# 802.1CB-2017/Cor1

Supporting material for maintenance item #343  
implementation

Christophe Mangin

November plenary session, Nov 12 2024

Figure 6-5 b.—Relay system with separated FRER capability, e.g., packet counting, on an output port.

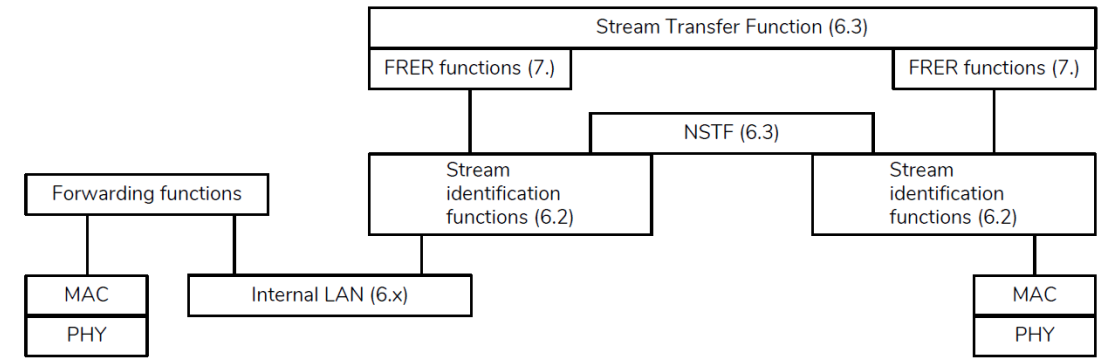
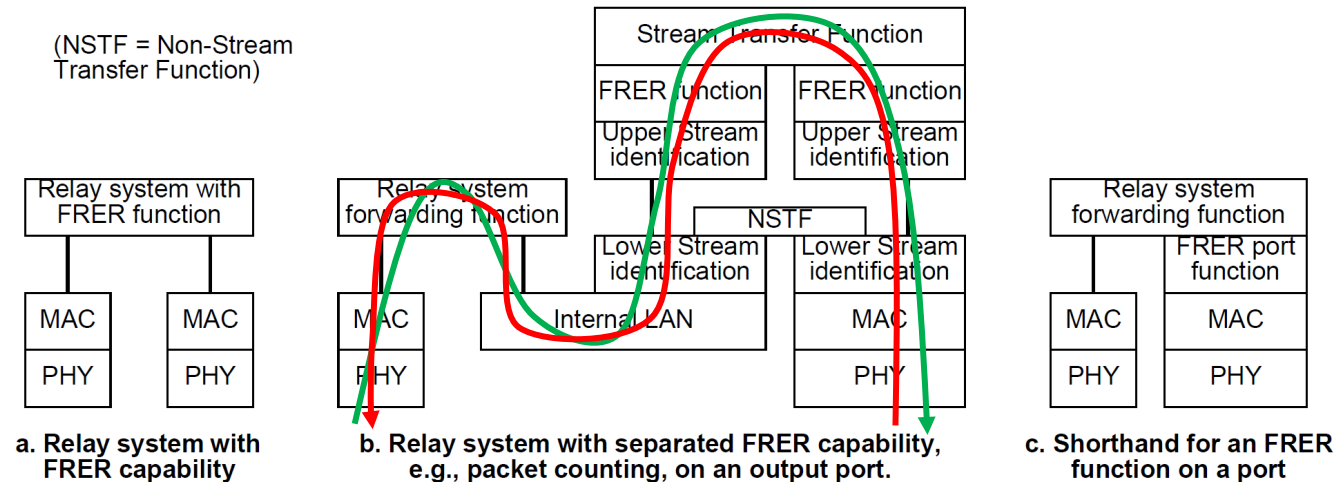
- Keep the differentiation between upper and lower stream id in b., especially if this configuration illustrates possible arrangements for both stream directions
- The text below the fig. should include some explanations consistent with the figure.

Figure 6-6—In- and out-facing functions

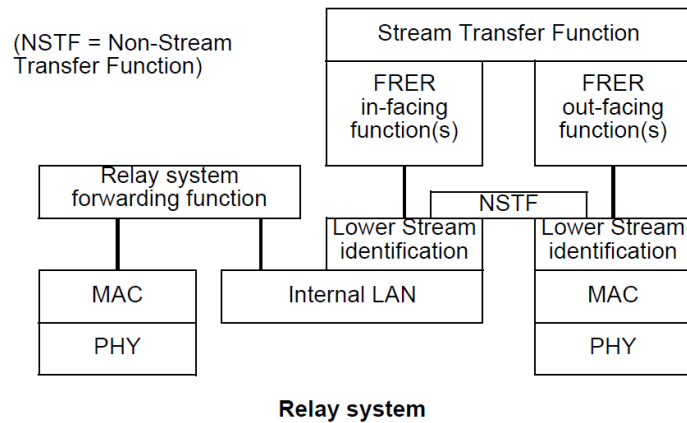
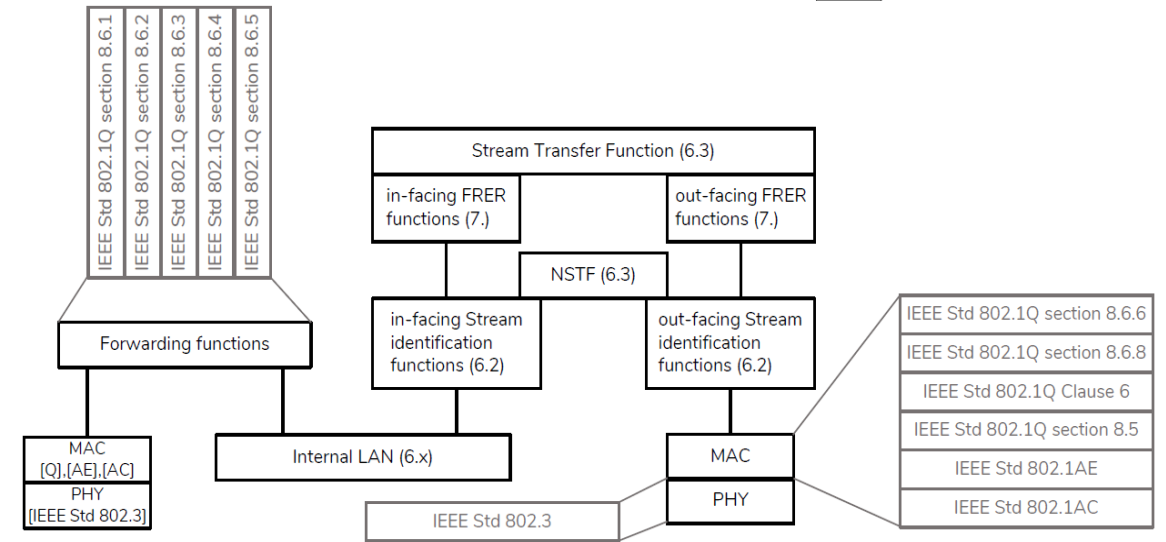
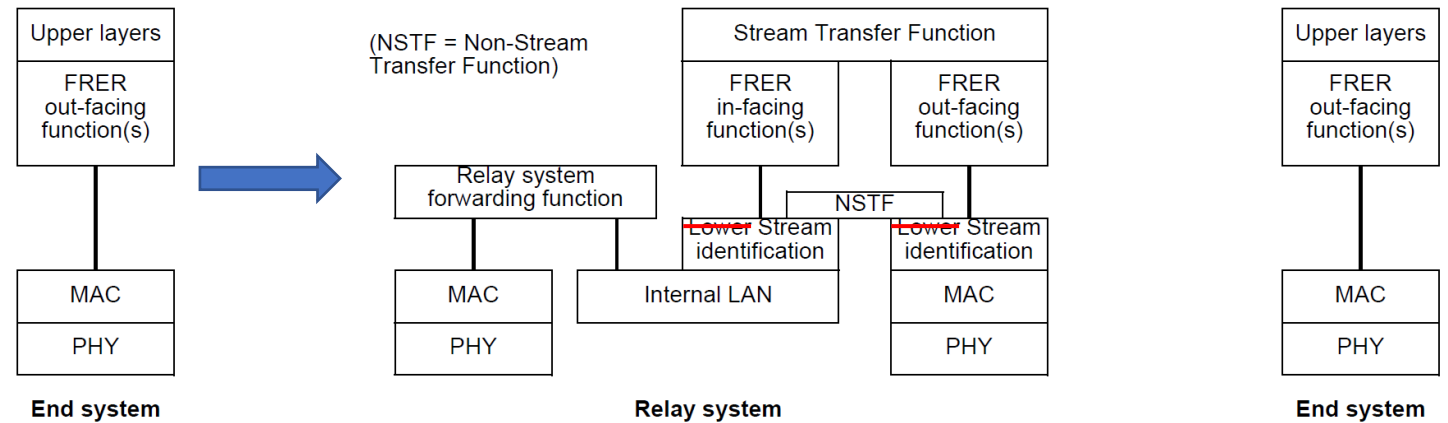
*Consistency with YANG ?*

Figure 8-1—FRER functions in an FRER C-component

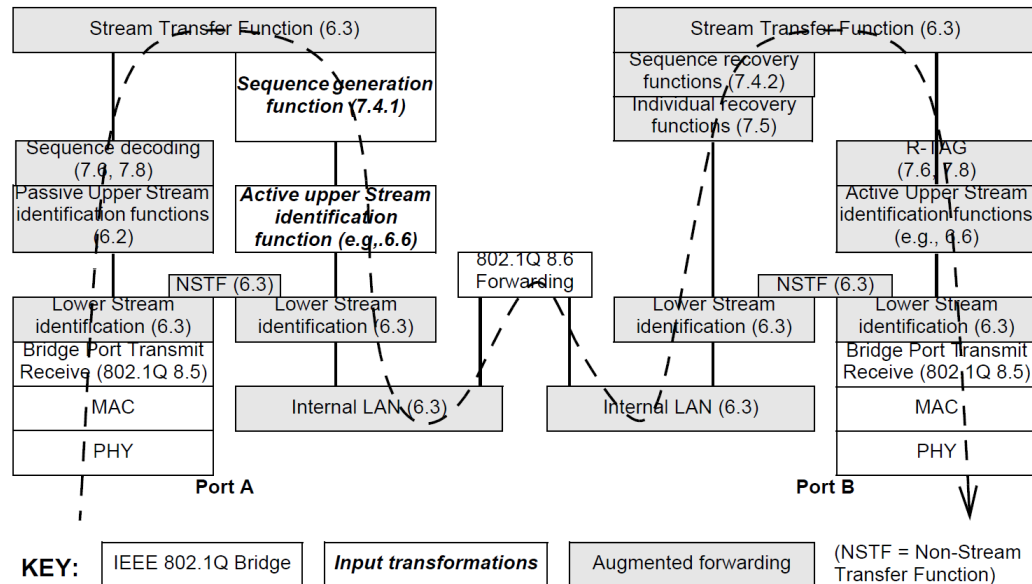
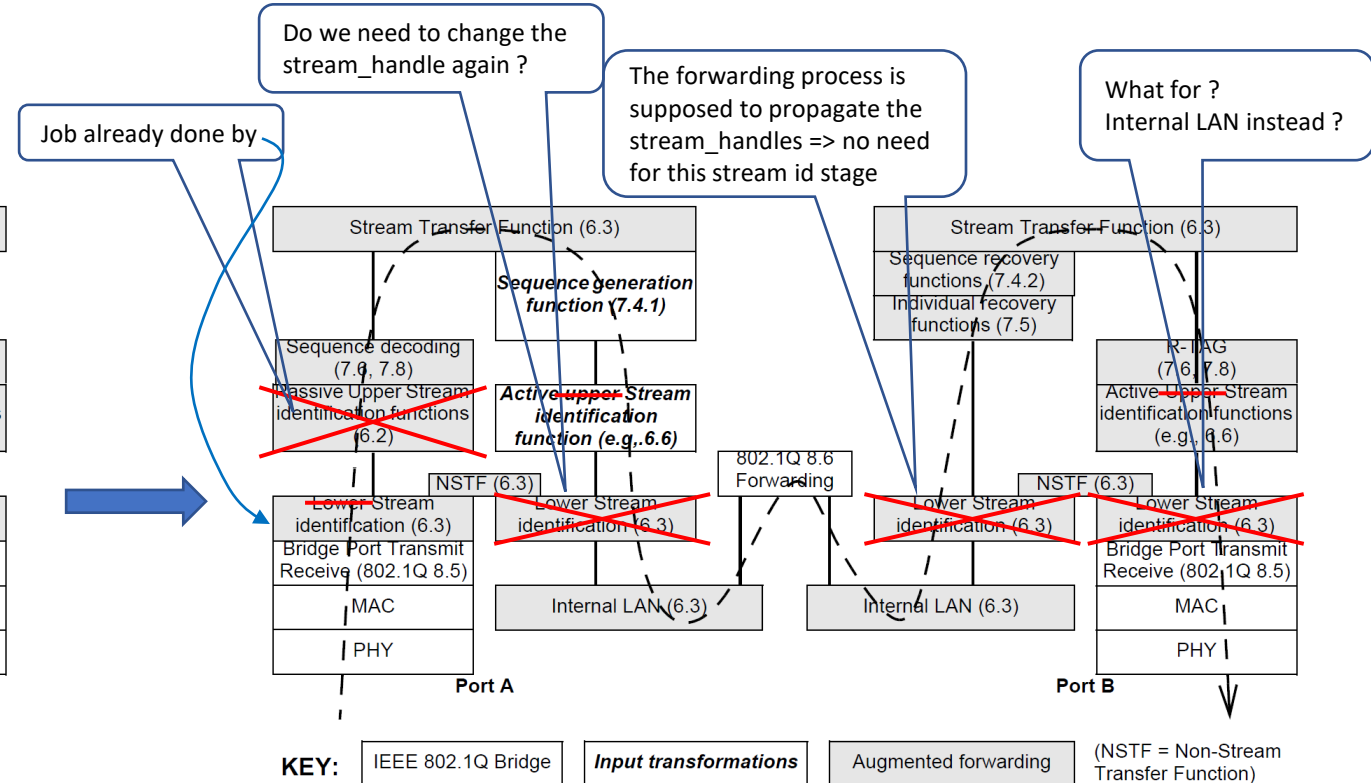
- Keep « upper » and « lower » between parenthesis ?
  - To keep some consistency with clause 6.3 (where they are introduced)

Figure 8-1—Relay system split

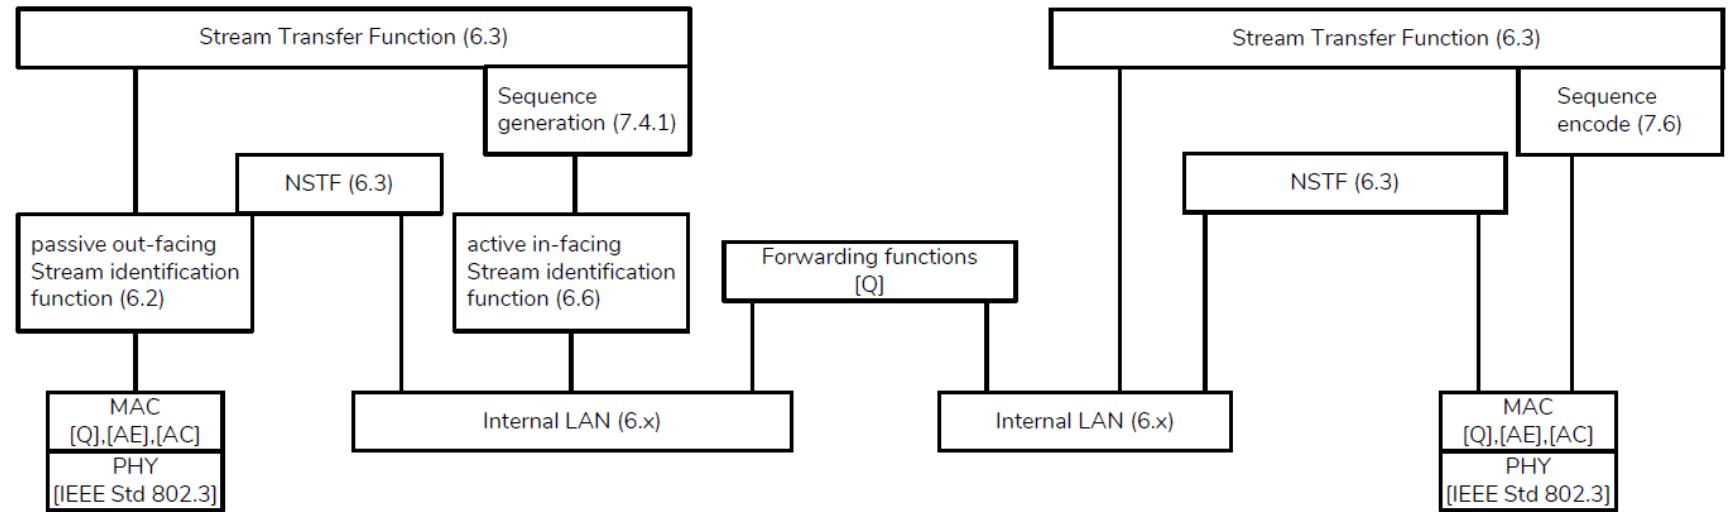
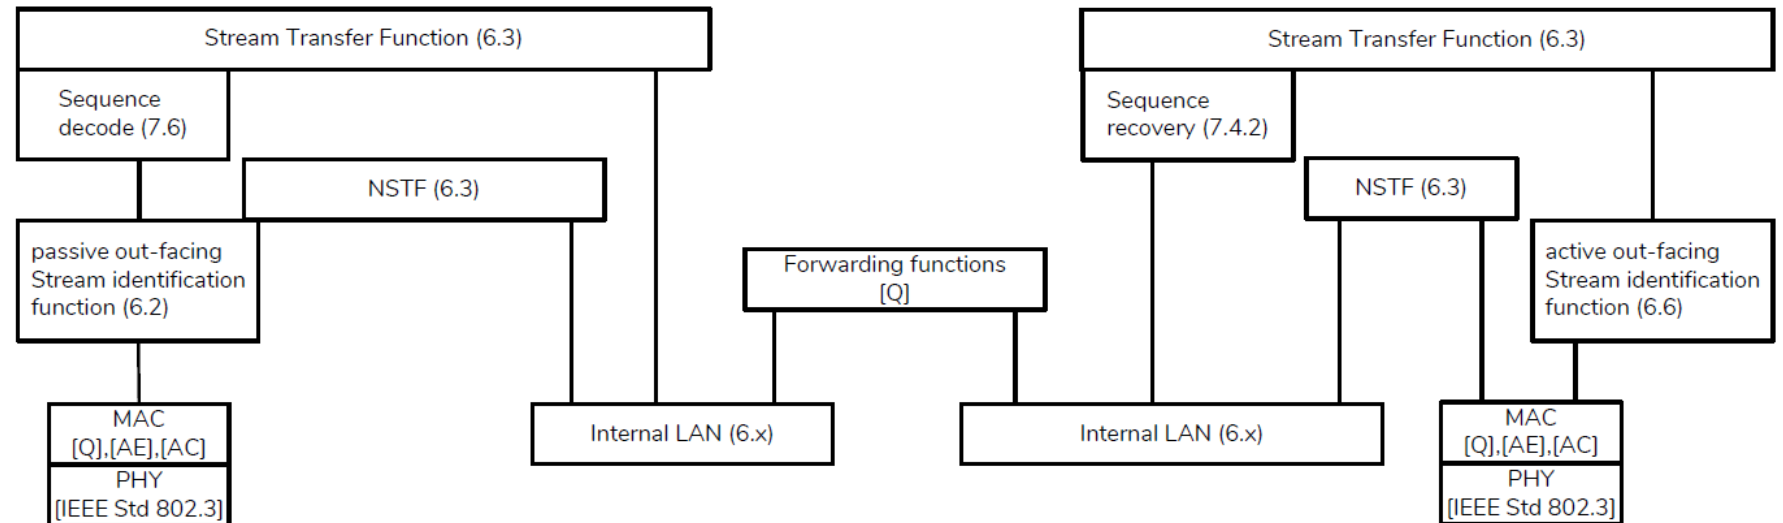
- Proposed changes in maintenance item
  - « In-facing » and « out-facing » stream id functions modelled in YANG ?

Figure C-5—Protocol stack for relay system B, proxying for End System A, in Figure C-4

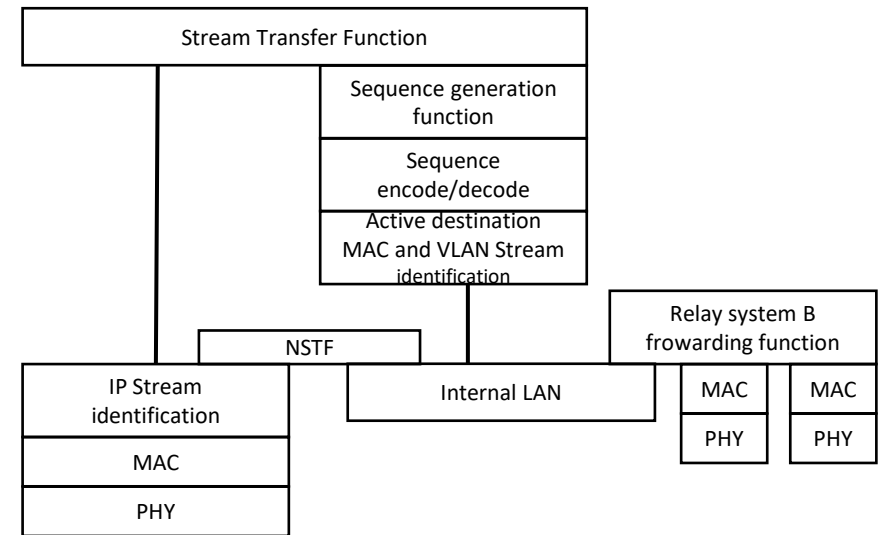
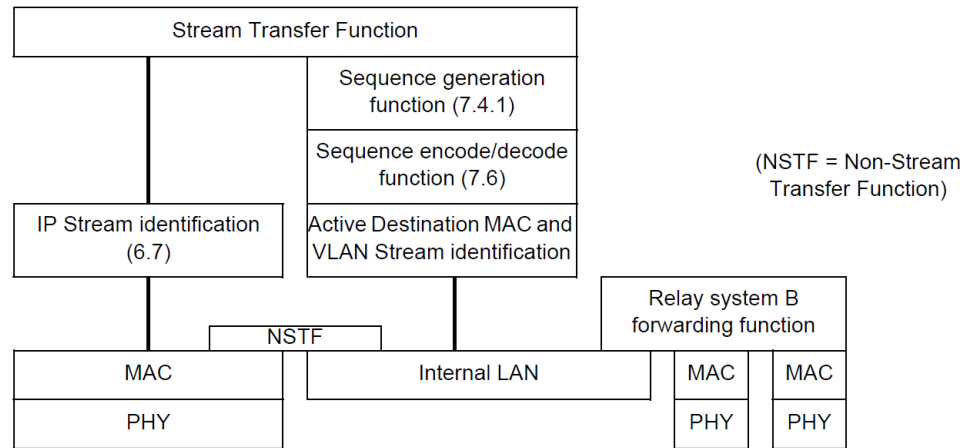
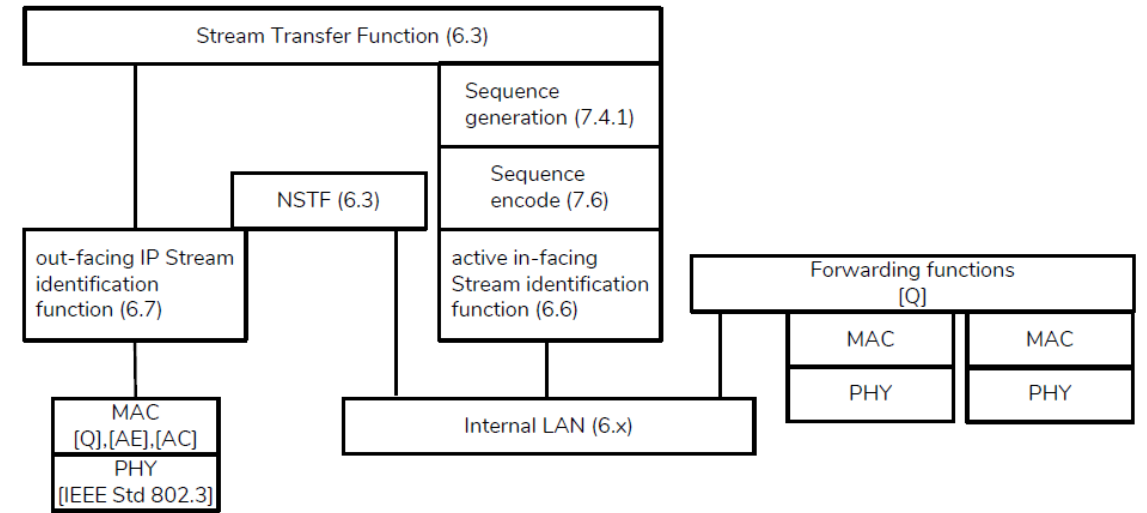
- This should be consistent with clause 8

Figure C-6—Protocol stack for relay system C in Figure C-4

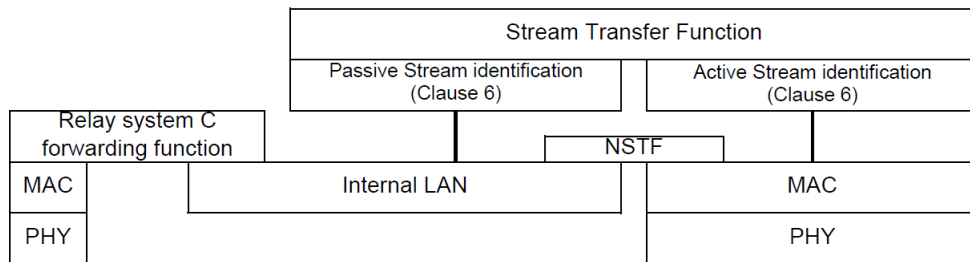
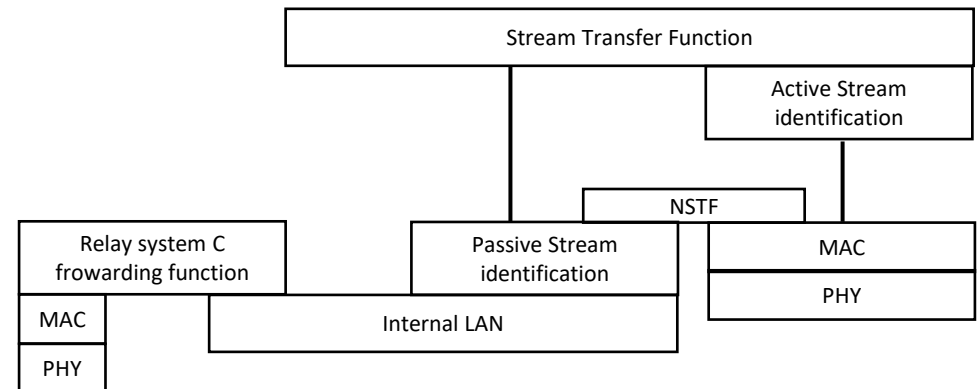
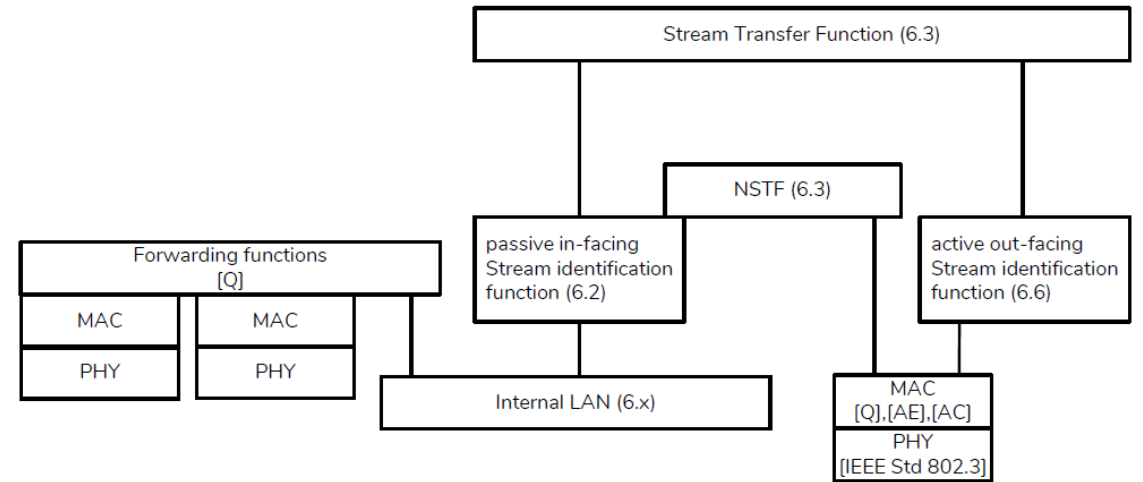
- This should be consistent with clause 8

Figure C-7—Protocol stack for relay system F in Figure C-4

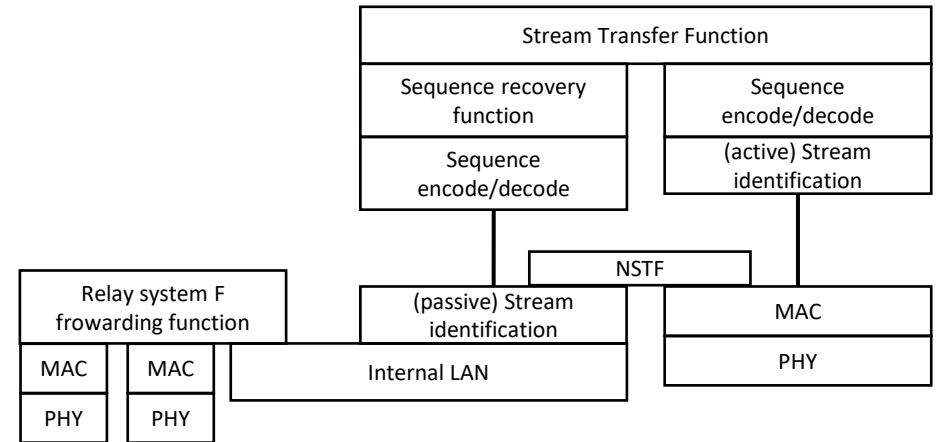
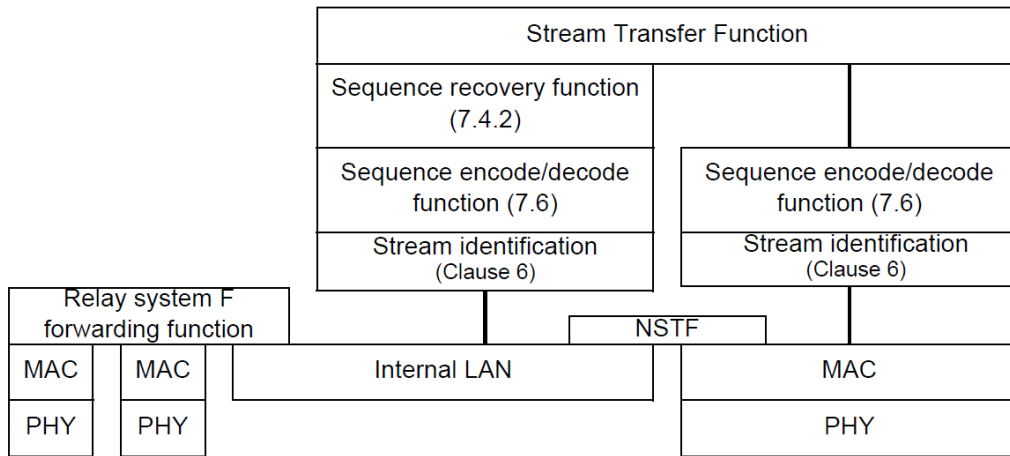
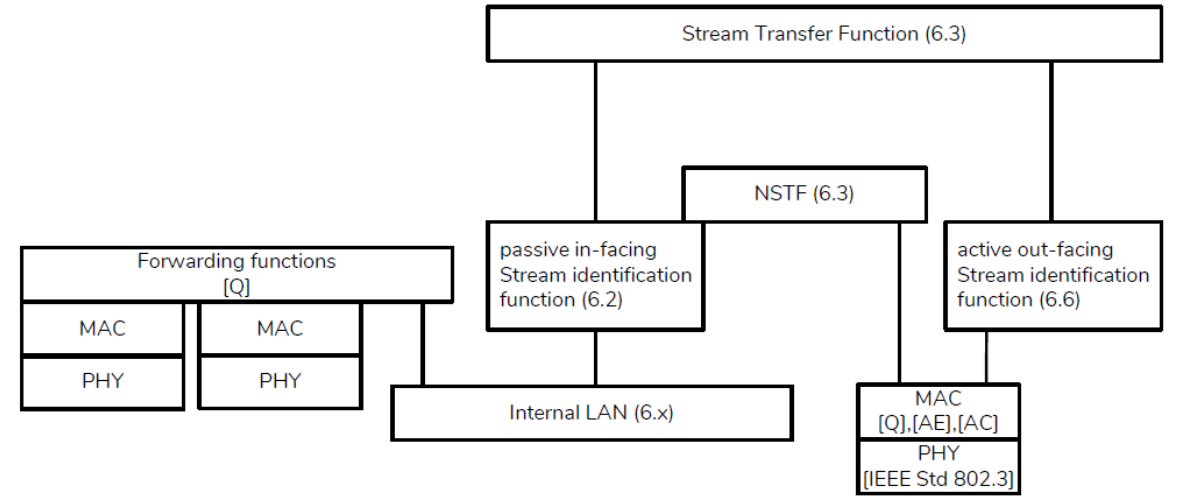
- This should be consistent with clause 8
